Mallinckrodt

March 24, 2006

RE: NRC Docket 40-06563, NRC License STB - 401

Clarification of Response to Certain NRC Requests for Additional Information about the C-T Phase II Decommissioning Plan

Figure 41. Maximum Annual Radiological Dose Versus Source Depth in Soil
(infinitely-thick source ratio 3 U series + 1 Th series produces 25 mrem/yr)

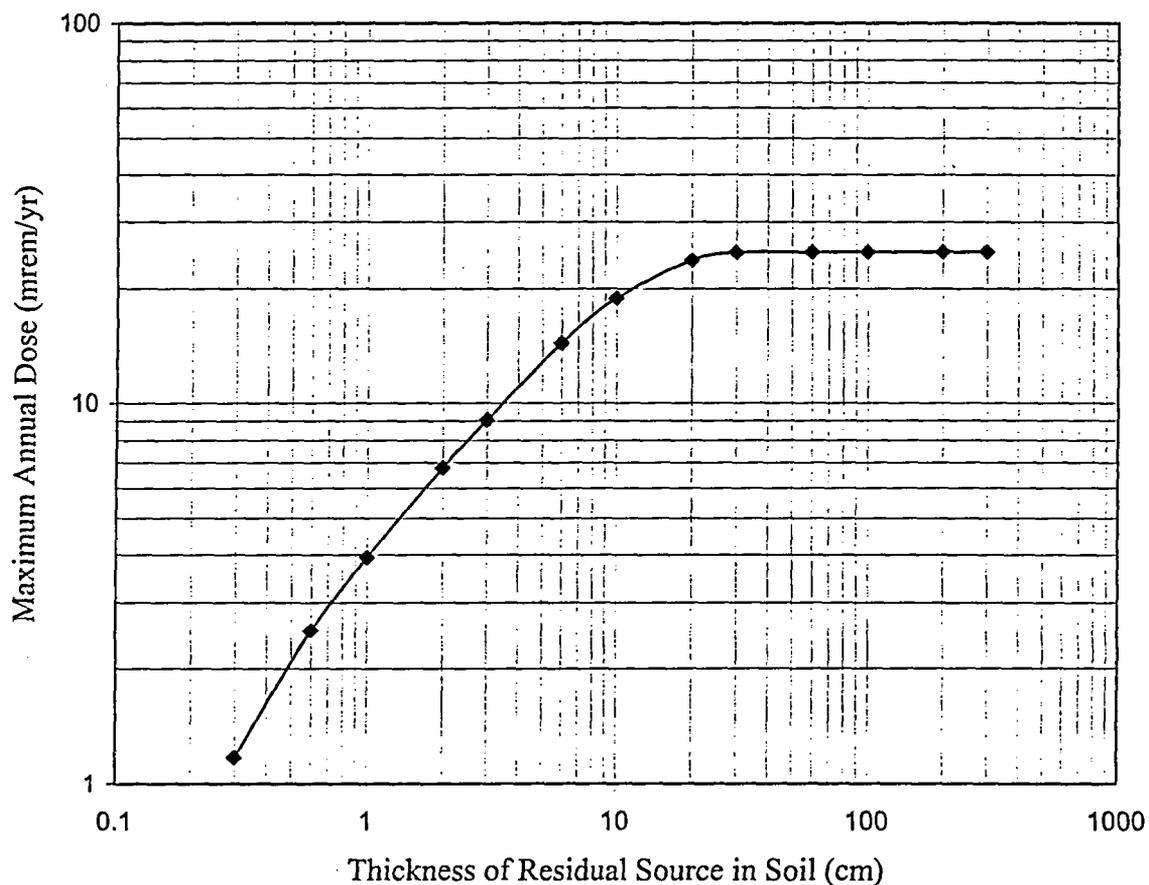
As noted in the NRC report of a meeting¹ between Mallinckrodt and NRC staff concerning radiological dose modeling pertaining to C-T Phase II Decommissioning, the NRC staff wants additional clarification in response to certain of its Requests for Additional Information. It also wants additional clarification of plans for final status survey of pavement and of soil beneath pavement. These interests are addressed in the following text.

The result of this analysis is summarized graphically in Figure 41. It determined that, in representative simulation, maximum dose rate by direct irradiation is reached asymptotically as the depth of the contaminated zone in topsoil reaches about 30 cm. Additional source thickness would not produce significantly greater dose rate.

This evaluation of the merit of our original modeling representing source thickness has demonstrated that the original basis of 2 meters source depth was exceedingly conservative in modeling dose and deriving DCGL. Nevertheless, we will represent the thickness of contaminated zone parameter as a variable in probabilistic modeling. It is being represented as a uniform distribution ranging from 0 to 1 meter thick. It is being represented as a uniform distribution because characterization survey soil sampling intervals are insufficient to resolve a well-defined gradient within this range. A maximum depth of 1 meter is more than sufficient to be a conservative representation insofar as direct irradiation is concerned.

Figure 43A. Cumulative Distribution of Indoor and Outdoor Shielding Fraction

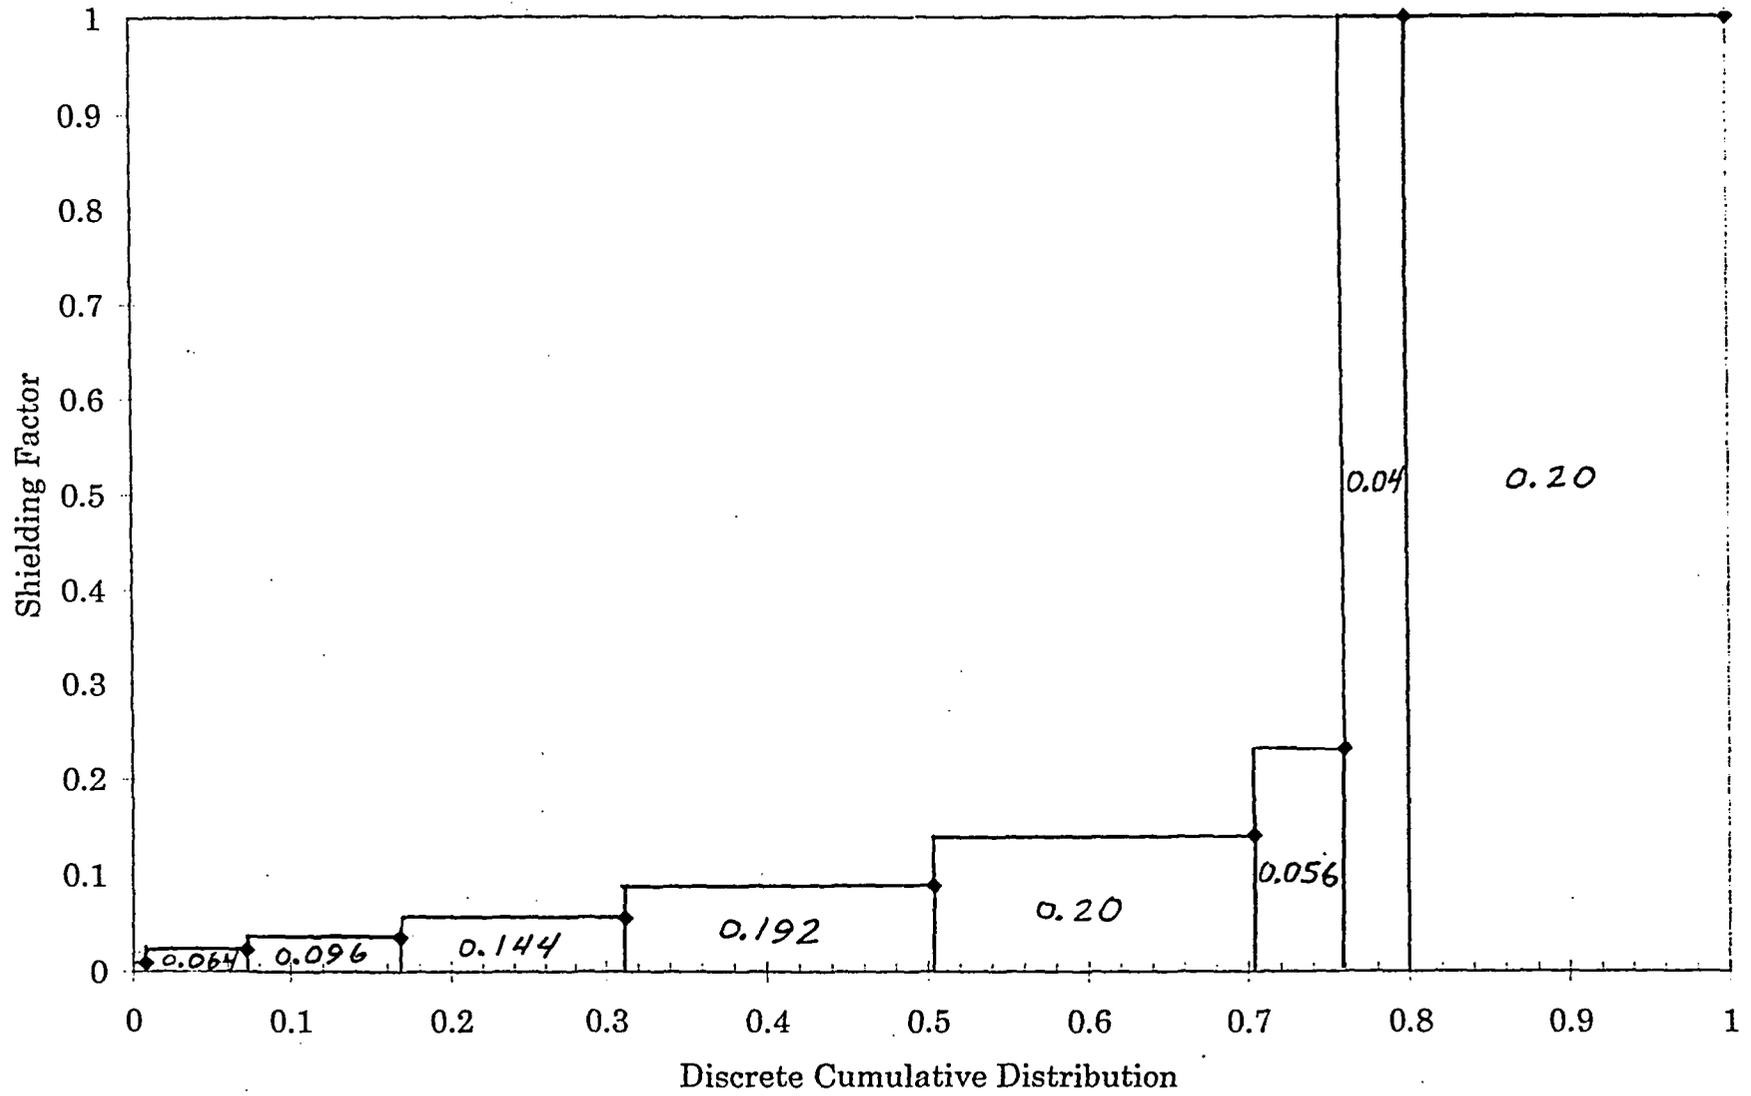
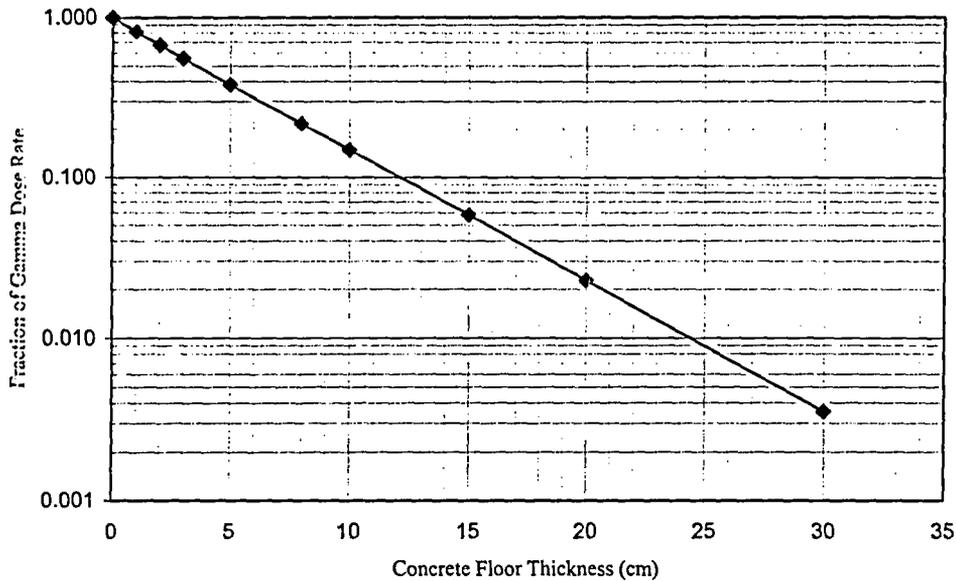
(c) The licensee selected an indoor gamma shielding factor of 0.17. In other words the licensee assumed that only 17% of outdoor gamma radiation can be penetrated indoors. The RESRAD default value is 0.7. The licensee indicated that Plant 5 has concrete slab floors or concrete walls with few windows. Therefore, the licensee assumed that the factor 0.17

DCGL have been revised to include the effect of probabilistic distribution of indoor gamma shielding factor.

An analysis of the effect of radiation attenuation by a building, especially floor thickness, on radiological dose for the portion of time a worker spends indoors during industrial occupation has been performed. Occupancy 20% of the time on bare ground, with gamma shielding factor = 1.0, is, in addition, assumed to apply deterministically while out-of-doors, even though most of Plant 5 is paved. Overall, then, dose modeling has been adjusted to simulate a person on bare ground about 24% of their time while on-site and thin shielding; an additional 5.6% of the time. This is illustrated diagrammatically in Figure 43 A. (same as CT 2 DP Appendix C, Attachment A, Figure C3.)

The gamma shielding factor indoors has been revised to treat it probabilistically and to assume a fractional occurrence on bare ground and a thin floor. Table 43-1 (same as CT 2DP Table 5-2) describes the discrete cumulative probability distribution simulating the external gamma shielding factor that is applicable indoors.

Figure 48 Refinement of CT 2 DP §5 Model for Pavement

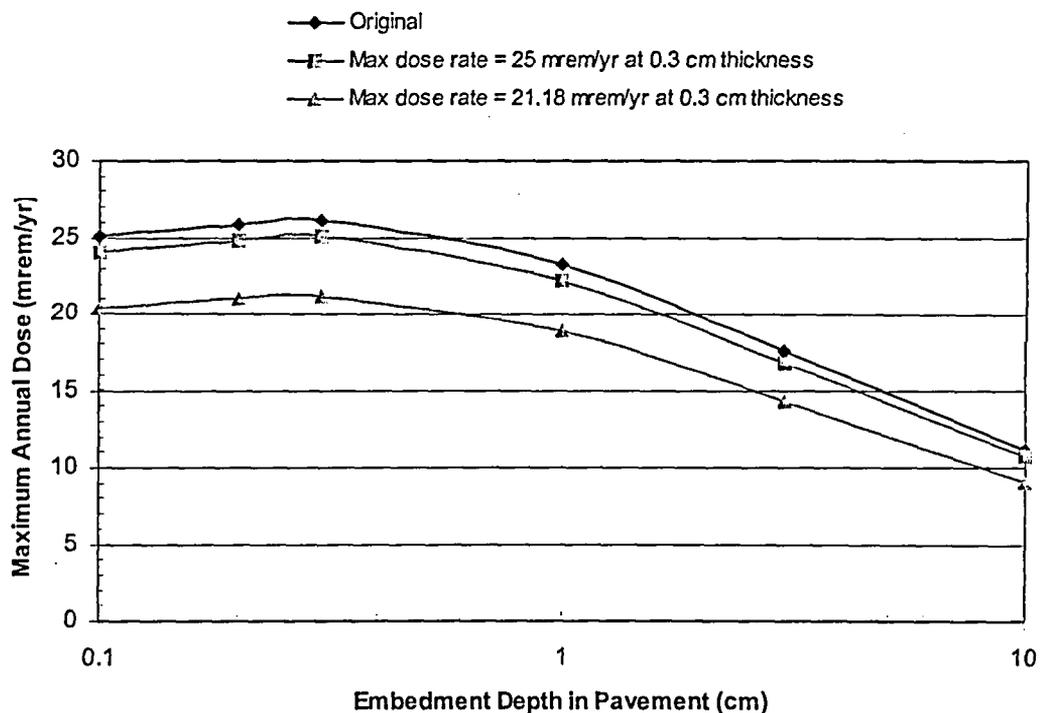
(h) Assumptions for the Industrial Worker Exposure to Pavement: For the exposure of industrial worker to residual radioactivity on pavements, the licensee made similar assumptions as those for the soil. However, the licensee assumed a thin layer of surface contamination on pavement with thickness of 0.1 cm. The licensee modified the approach to convert volumetric dose analysis results into surface activity results (e.g., dpm/100 cm²). This was done through derivation of the radionuclide volumetric dose factor (mrem/y per pCi/g), converting this factor into areal density factor pCi/100 cm² (e.g., by assuming a thickness of pavement of 0.1 cm and a density of 1.5 g/cm³) corresponding to 25 mrem/y and then converting the pCi into dpm (e.g., by multiplying by 2.22). Therefore, considering the volumetric dose analysis approach the following parameters and assumptions were made for industrial worker exposure to the pavement source: (i) Contaminated Zone: the

The licensee needs to verify that contamination only exist in a pavement medium of 0.1 cm thickness and no contamination below this thin crust of the pavement. In addition, by assuming an erosion rate of zero the licensee assumed that the pavement would be maintained through a performance period of 1000 years. The licensee needs to verify these assumptions and provide data and a rationale that the thin pavement layer would be maintained over a 1000 year time-frame.

A premise of CT 2 DP, §5, Table 5-3 is that an equivalent areal density of CT residue would produce less dose when embedded than when accumulated on the surface; hence the source was originally modeled as concentrated into a 0.1 cm layer on the surface. Unexpectedly, maximum total dose occurs when the source is 0.2 to 0.3 cm thick, or deep, as illustrated in Figure 48, curve “♦ Original.”

This observation prompted derivation of $DCGL_W$ assuming 0.3 cm contaminant thickness of the long-lived radionuclides in the uranium series, the actinium (U^{235}) series, and the thorium series, assuming short-lived nuclides (<180 day half-life) to be in transient radioactive equilibrium with their parent. The revised result appears here in Table 48-1. The result of this refinement is illustrated in Figure 48 by the curve, “■ Max. Dose Rate = 25 mrem/yr at 0.3 cm thickness”. Thus, if contamination were on the surface or even if it were unevenly embedded into pavement or a building slab, controlling to a maximum areal density specified in Table 48-1 would assure that maximum annual dose would not exceed 25 mrem/yr.

Figure 48, curve “▲ Max dose rate = 21.18 mrem/yr at 0.3 cm thickness,” confirms that the revised DCGL_w in Table 48-2, to become CT 2 DP §5, Table 5-4 (replacing Table 5-3),¹¹ would constrain maximum potential annual dose from contamination on pavement, even if embedded, to no more than 21.2 mrem/yr.
